# Coulderton and Nethertown, Cumbria

Natural England's Variation Report to the Secretary of State

Coastal Access Variation Report VR2  
1st August 2018

### Section Details – Map VR2a: Coneyside, near Coulderton

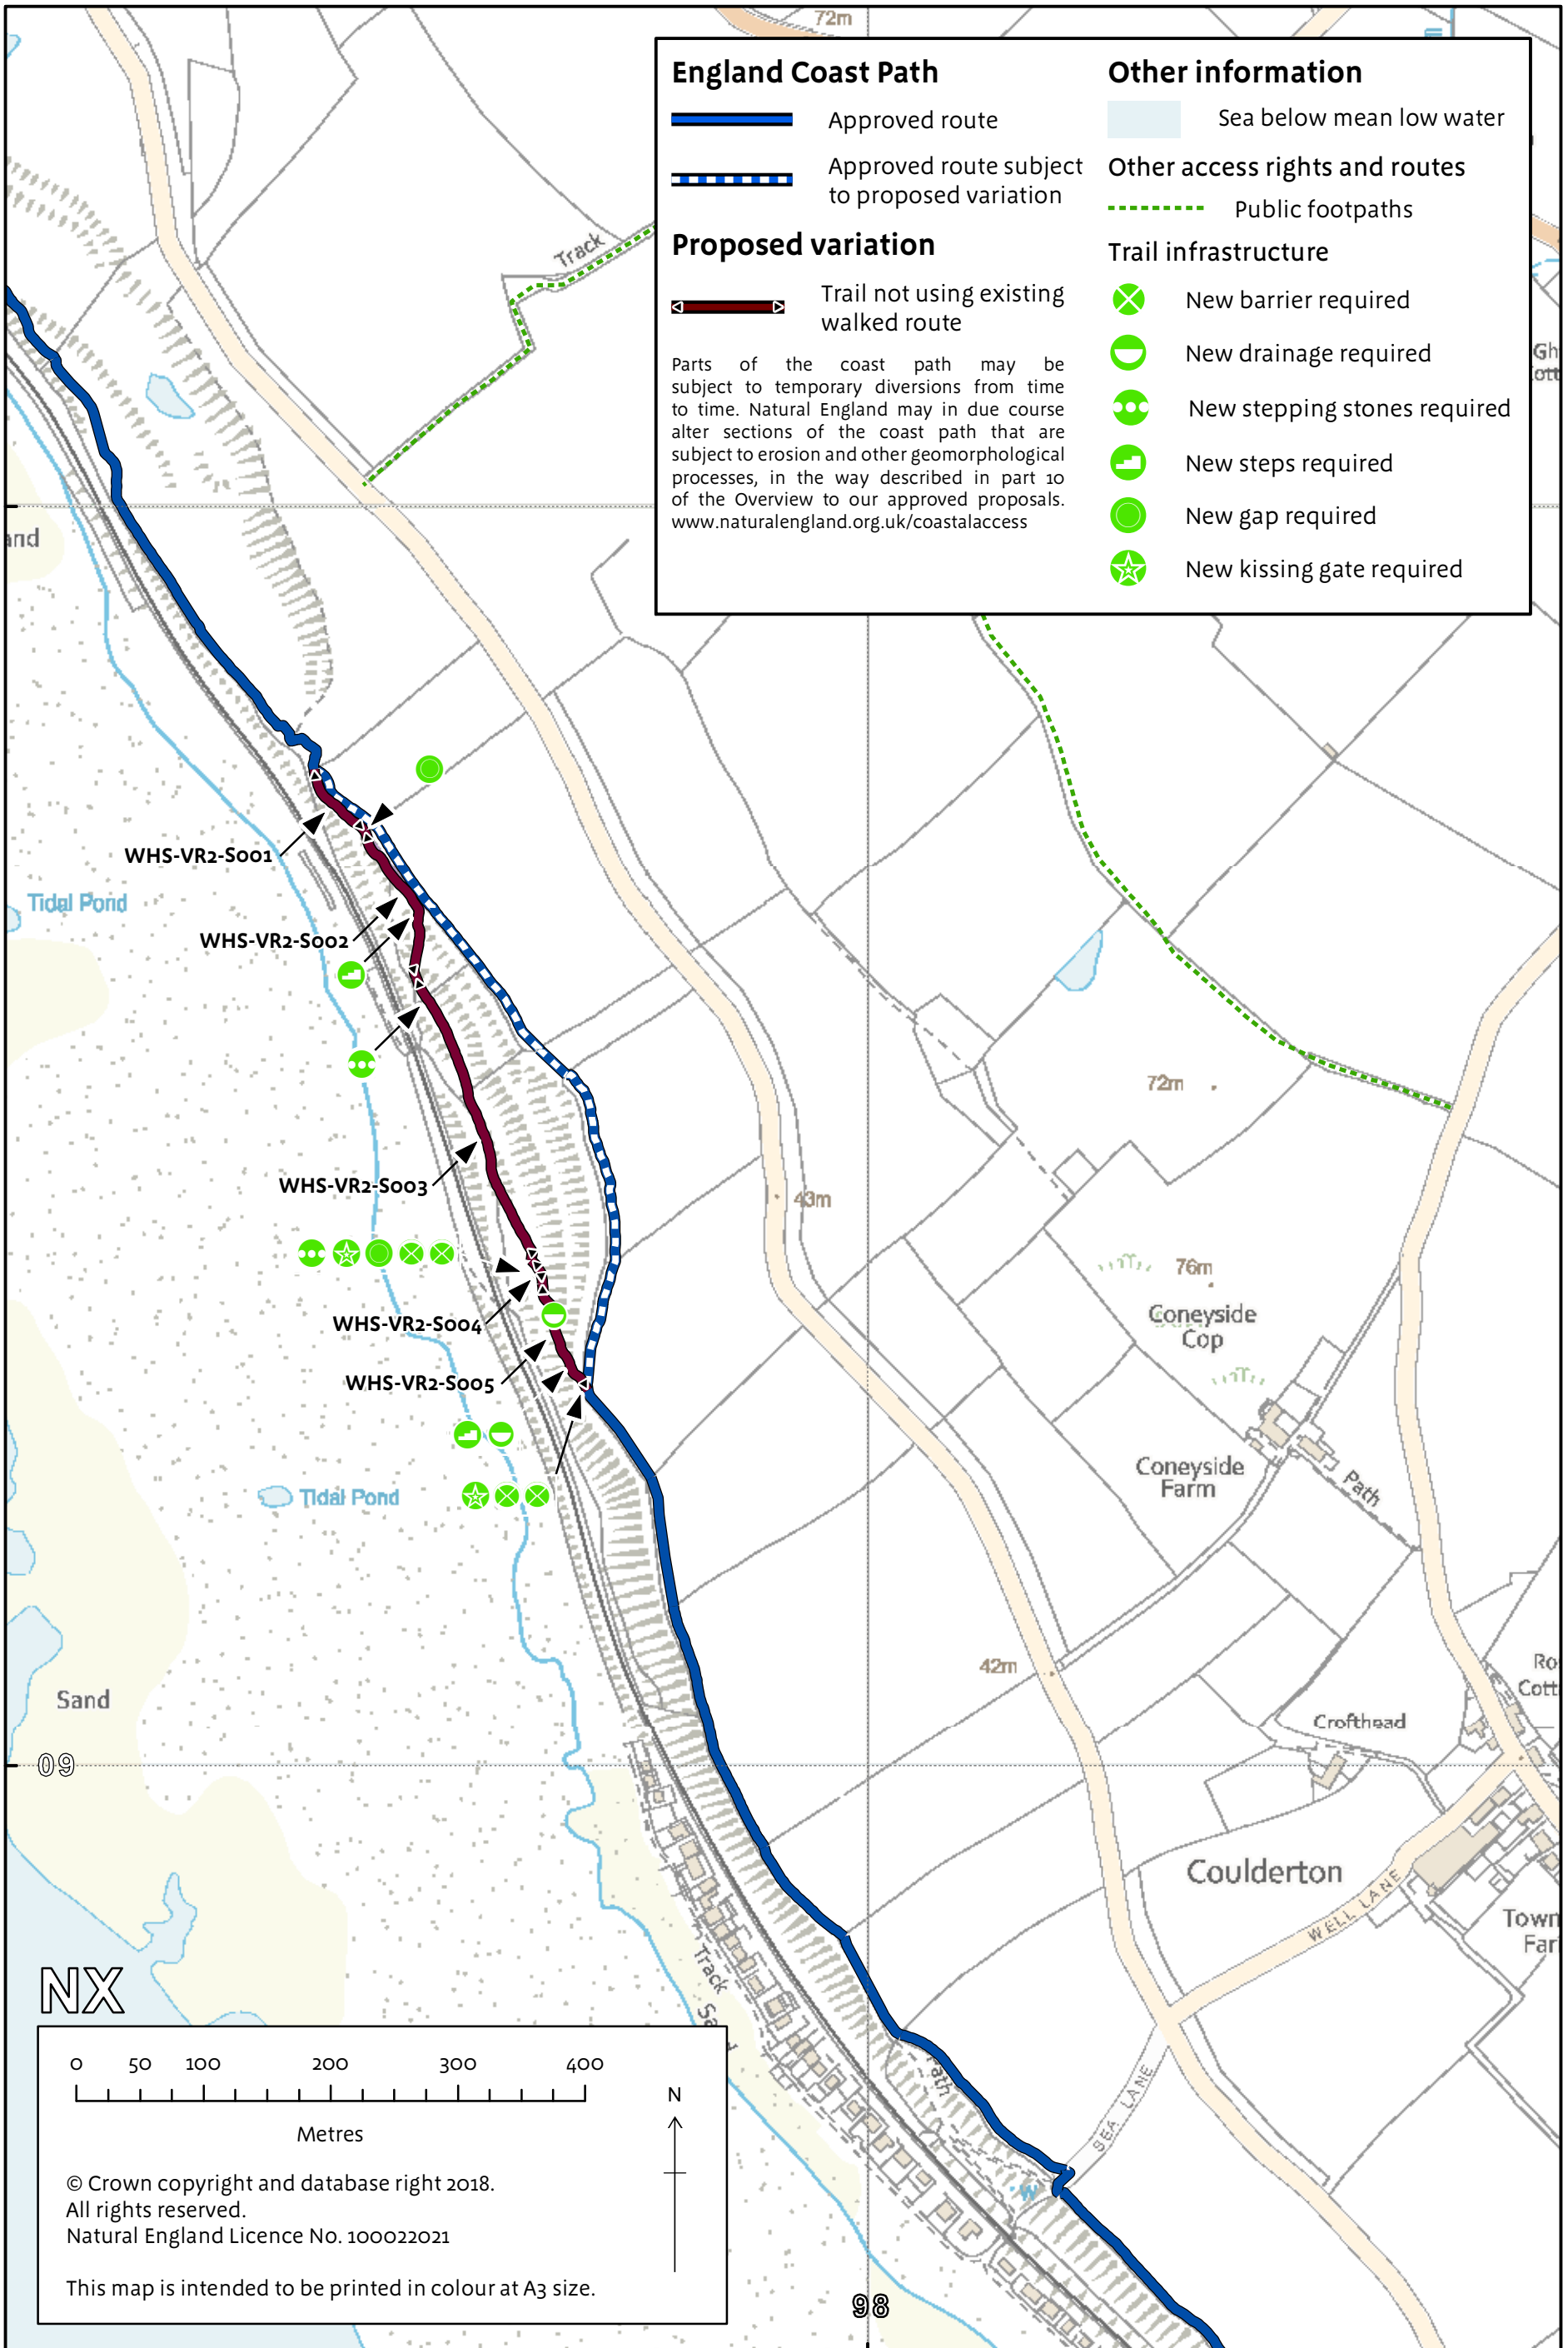
The approved route of the England Coast Path would install the England Coast Path along an entirely new access route, on the seaward edge of a number of fields (see map VR2a).

However, since this alignment was approved, Network Rail has completed bank stabilisation and drainage works on land just seaward of the approved route. This presents an opportunity to realign the route onto the adjacent semi-improved pasture between the approved route and the railway line. Natural England believes that the proposed variation will provide a more pleasant walking experience and reduce impacts on land management practices.

Our proposal (map VR2a) is to re-route the path to the seaward side of its approved alignment to a new alignment on the adjacent land gently sloping down towards the coastal railway (proposed route sections WHS-VR2-S001 to WHS-VR2-S005). The proposed realignment would see the England Coast Path following this slightly more seawards route for approximately half a kilometre, before re-joining the approved route at the seaward edge of fields further south, towards Coulderton. This change would avoid the requirement to create access points through a number of hedge-banks.

Way-markers would be necessary to guide people along the new route. Pedestrian gates would be installed to allow access through intervening field boundaries, as shown on map VR2a. As with most parts of the England Coast Path, these access points would be 'kissing gates' of a design to ensure maximum accessibility whilst ensuring control of grazing stock. We would also install steps on steeper parts of this route.

Adjacent to route section WHS-VR2-S002, the landward boundary of the coastal margin is to coincide with various features landward of the trail shown on VR2a.

### Section Details – Map VR2b: South of Nethertown

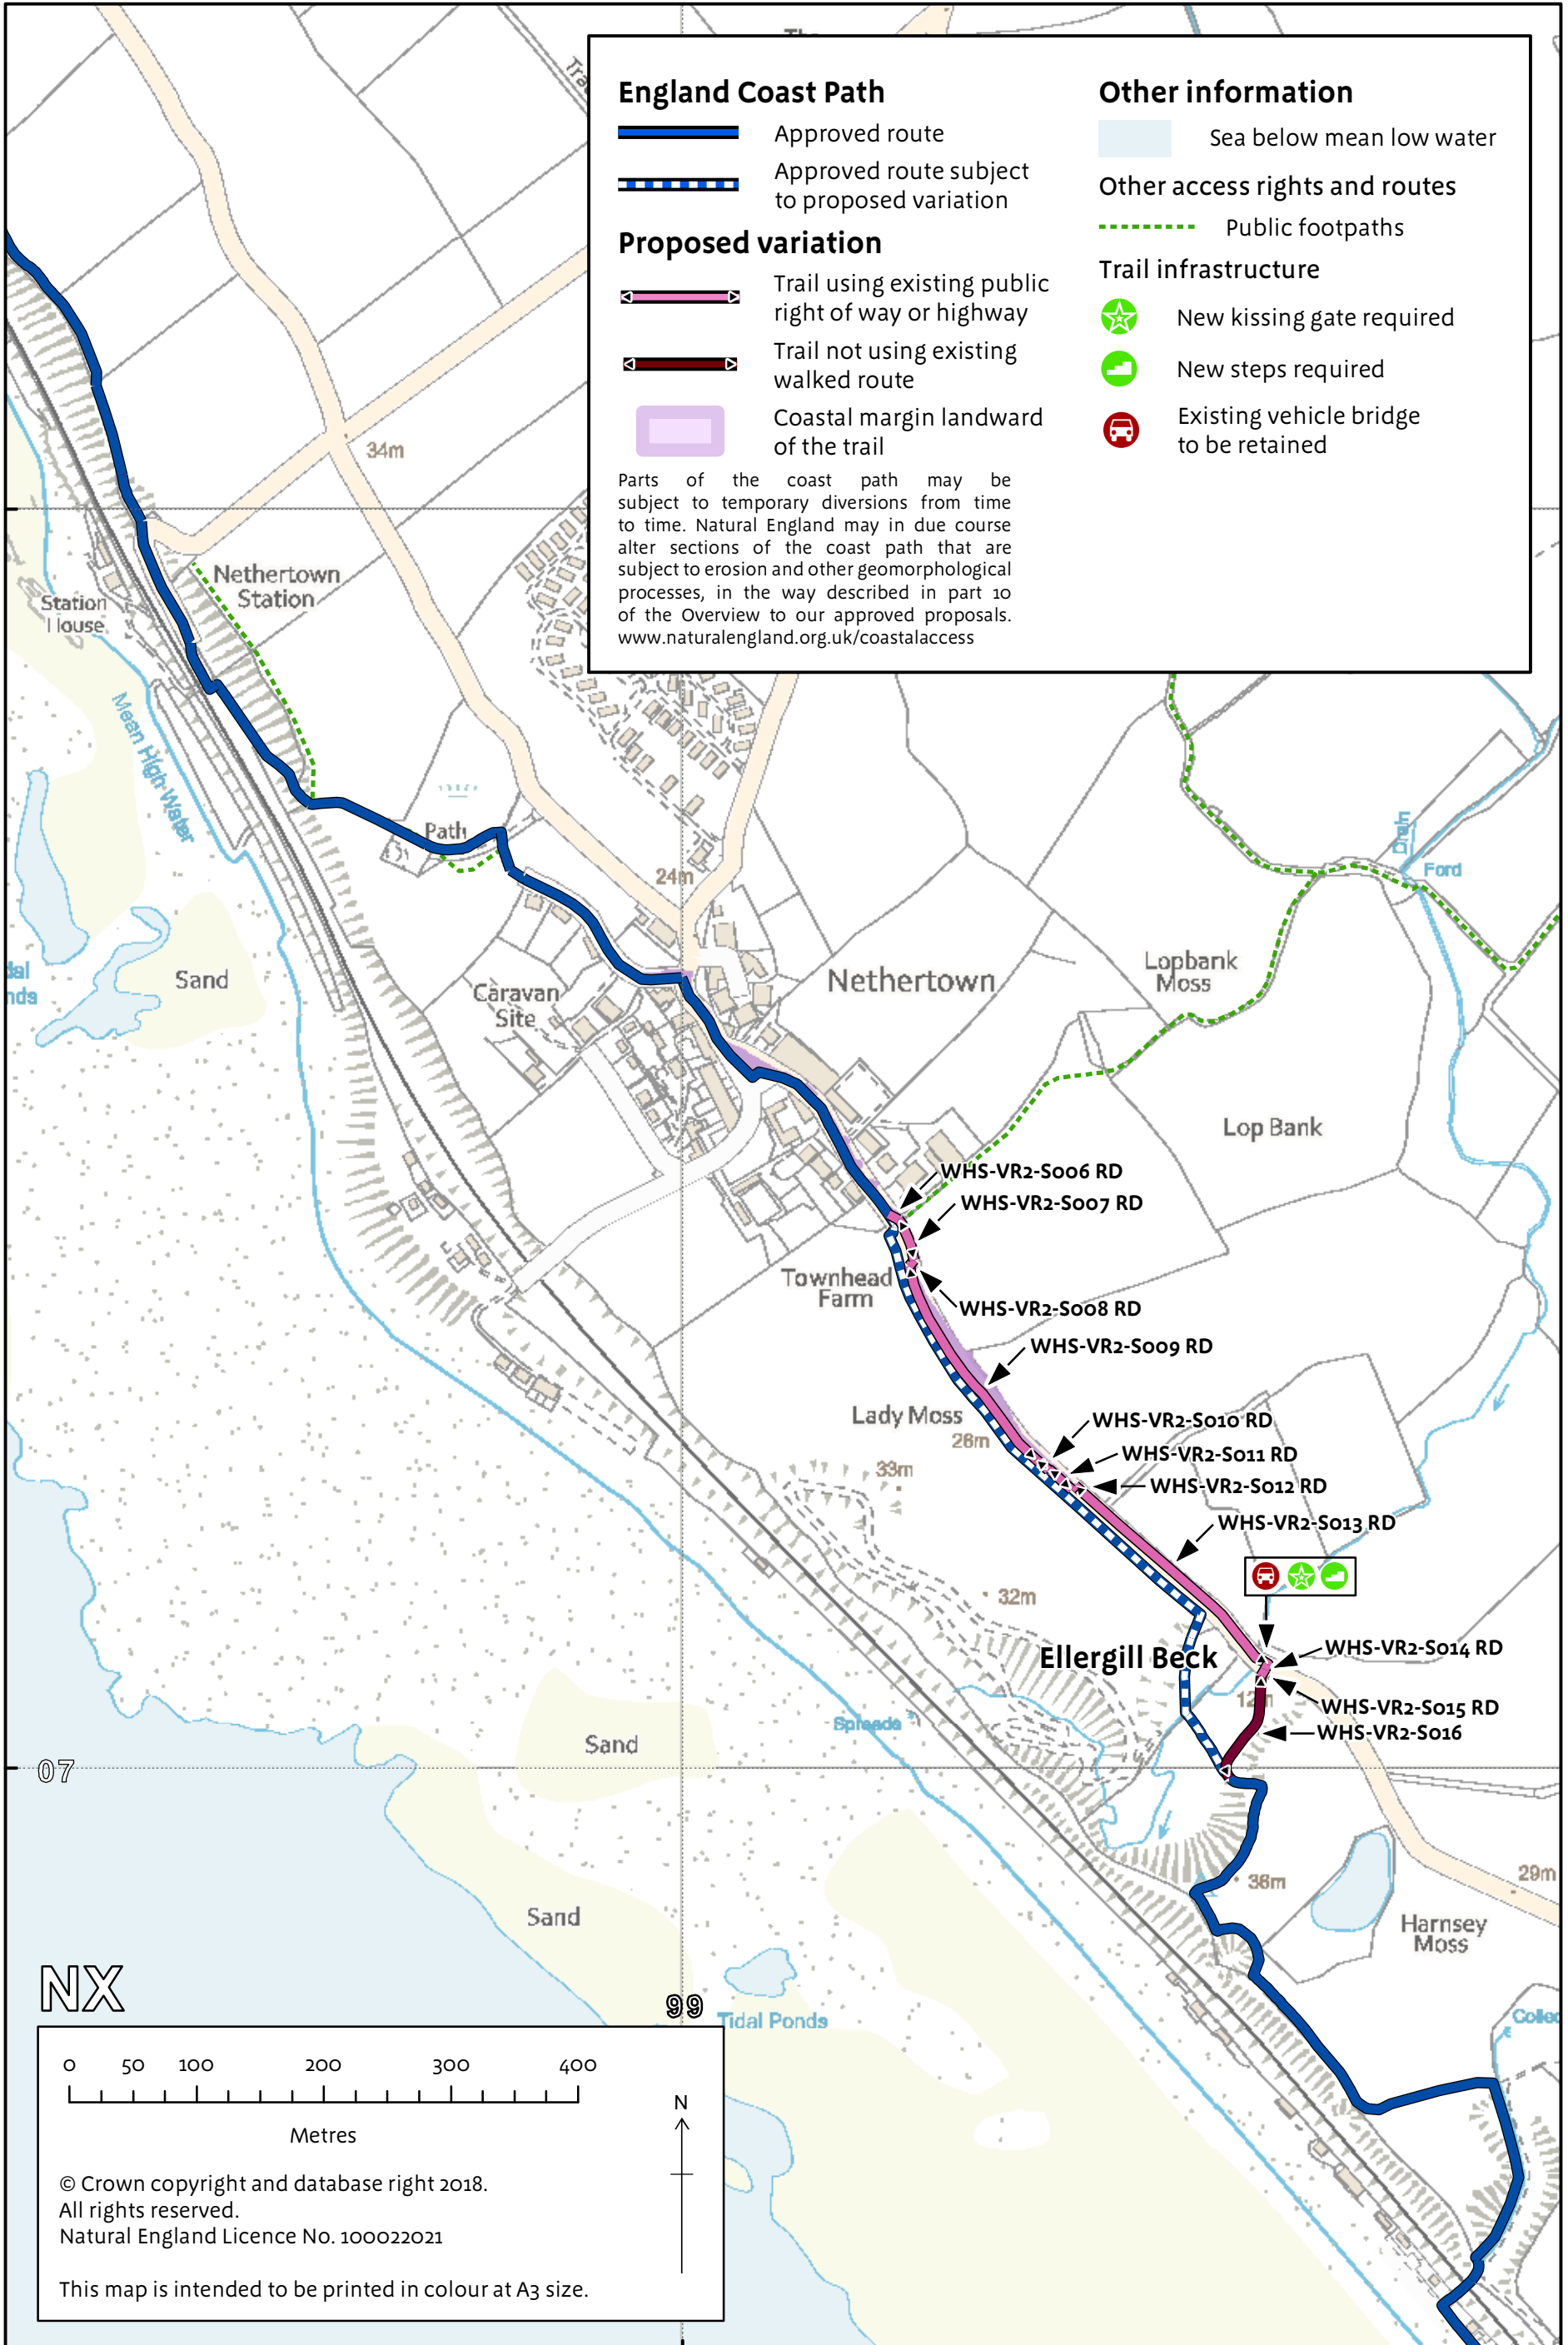
The approved route of the England Coast Path would install the England Coast Path along an entirely new access route, on the landward edge of fields southeast of Nethertown. Just west of Ellergill Beck, the route would turn south, away from the road, crossing the beck via a new footbridge, before continuing along the seaward edge of adjoining fields (see map VR2b).

Our proposal (map VR2b) is to re-route the path as it exits the southern edge of Nethertown; slightly inland of its approved alignment. The proposed route would follow the roadside, mostly using verges, for approximately 450 metres, before crossing Ellergill Beck via the existing road bridge, then turning south to join the previously approved route at NX 994 070 (proposed route sections WHS-VR2-S006 to WHS-VR2-S016). These changes would remove the path from a densely stocked field and also remove the requirement for a new pedestrian footbridge over Ellergill Beck.

Some works would be undertaken to improve sight lines along the road, particularly in relation to the proposed road crossing points, and in the levelling or cutting of some of the grass verge to create space to walk off-road. We would also install a kissing gate and steps, where the path joins the road, as shown on map VR2b.

Adjacent to route section WHS-VR2-S006, the landward boundary of the coastal margin is to coincide with the landward edge of the road shown as the trail on VR2b.
